| Description: Crosstube Assembly, Mid Aft | | Part Number: | D206-667-247TRN |

| DRAWING NO. D206-667-247 | TITLE CROSSTUBE ASS'Y (206L MID AFT) | REV. A | DART AEROSPACE LTD ENGINEERING ORDER | | D.E.O. NO. D206-667-247-A-1 | SHEET NO. SHEET 1 OF 1 | SCALE NTS |

PURPOSE:

REPLACE MAGNOBOND WITH PROSEAL.

DRAWING NO. D206-667-247
TITLE CROSSTUBE ASS'Y (206L MID AFT)

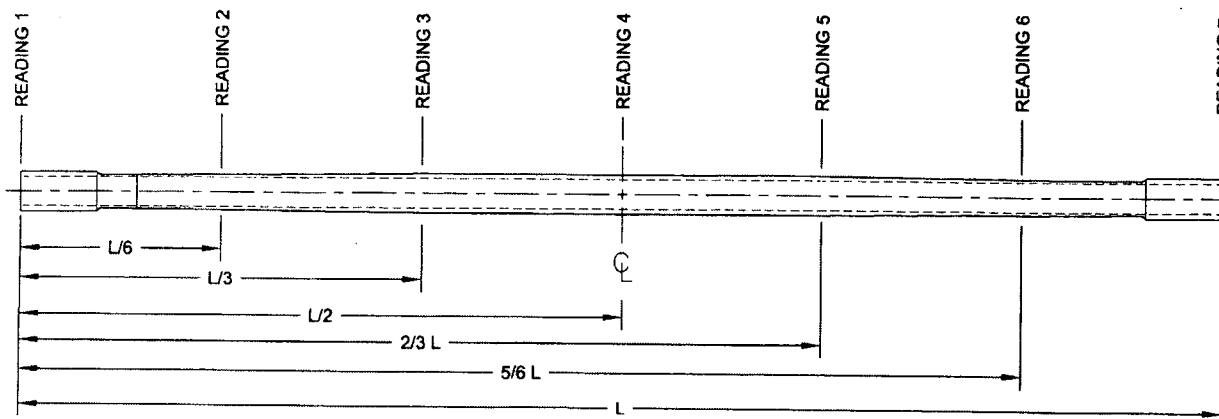
NOTE 12 & 15, SHEET 1 IS AMENDED AS FOLLOWS:

- 12) INSTALL D2892-1 SUPPORT USING 0.03" TO 0.06" THICK LAYER OF MAGNOBOND 6398 PER QSI 015. LET CURE FOR 12 HOURS AFTER INSTALLATION AND PRIOR TO PACKAGING.
- 15) TORQUE CLAMPS 80 TO 100 IN-LB. ENSURE AT LEAST 1.5 THREADS SHOWING IN SAFETY AND THAT NUT HAS NOT BOTTOMED-OUT AFTER TORQUING.

- 12) TO INSTALL D2892-1 SUPPORT: ABRABE MATING SURFACE OF SUPPORT AND CROSSTUBE WITH 180-GRIT SANDPAPER AND REMOVE RESIDUE WITH MEK (OR EQUIVALENT). APPLY A 0.04" TO 0.07" THICK LAYER OF PROSEAL 890 CLASS B-2 (OR AMS-S-8802 CLASS B-2) SEALANT TO MATING SURFACE OF SUPPORT.
- 15) TORQUE CLAMPS 80 TO 100 IN-LB. ENSURE AT LEAST 1.5 THREADS SHOWING IN SAFETY AND THAT NUT HAS NOT BOTTOMED-OUT AFTER TORQUING. **PRIOR TO PACKAGING, RE-CHECK TORQUE ON CLAMPS AFTER PROSEAL 890 SEALANT HAS CURED FOR 72 HOURS.**
